NEW ELEMENTARY SCHOOL
9801 HIGHLAND KNOLLS DR
BAKERSFIELD
CALIFORNIA
93306

NEW MIDDLE SCHOOL
4115 VINELAND ROAD
BAKERSFIELD
CALIFORNIA
93306

SHEET TITLE
LIGHTING PLAN
BUILDING M

SHEET IDENTIFICATION NUMBER
E-132M
SHEET OF

LIGHTING PLAN BUILDING M

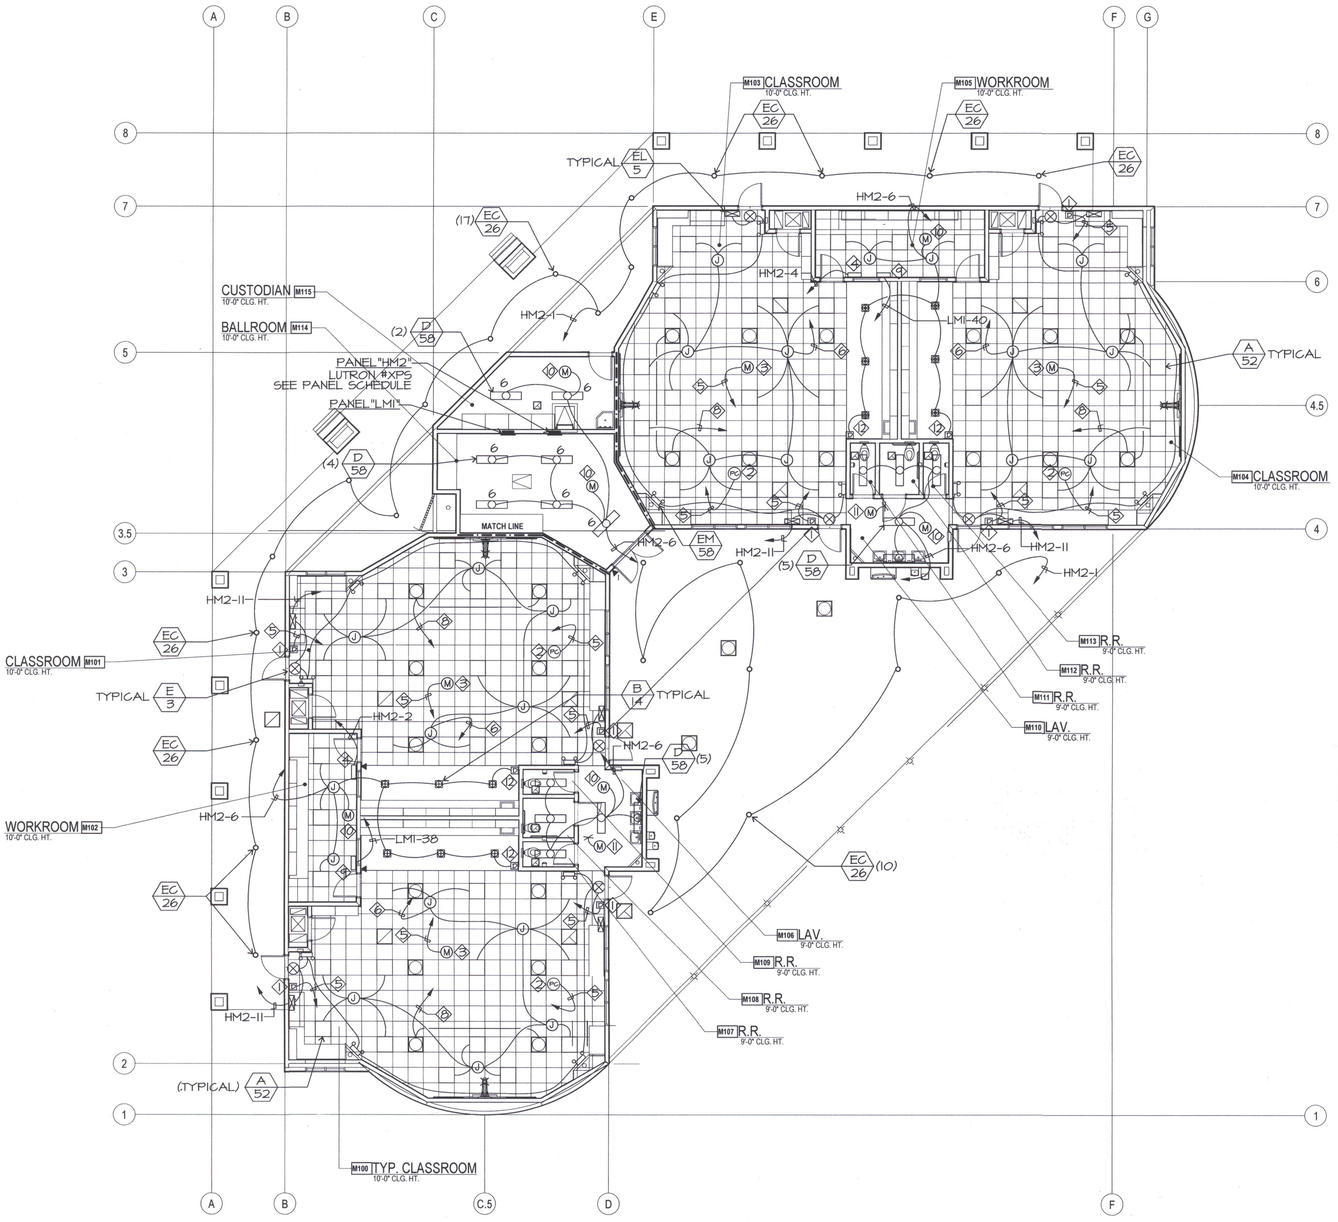
Sheet E-132M, Room M103, should there be a (D) <1> next to this door? Yes.

The Electrical Lighting Plan layouts shown for Rooms M108, M109, M110, M111, M112 and M113 differ from those locations shown on the Architectural Reflected Ceiling Plan. Please advise on which lighting layouts are correct for these (6) rooms.

Reference RFI #292 & Sheets E132C, E132D, E132E, E132F, E132G, E132M, E132N & E132P
Per the response to RFI #292, the solatubes in the classrooms are to be controlled via an Energi Savr Node. However, per the attached cut sheets, the solatubes appear to need separate DC switching to be controlled, which is not shown on the drawings. The plans only show to supply 120V to the solatubes via the Energi Savr Nodes. Do the classrooms need DC switching to be added as a means of controlling the solatubes? If so, please advise on the requirements.

Contact closure on Energi Savr Node will operate solatube shutter. Wire verified this with Solatube and Lutron.
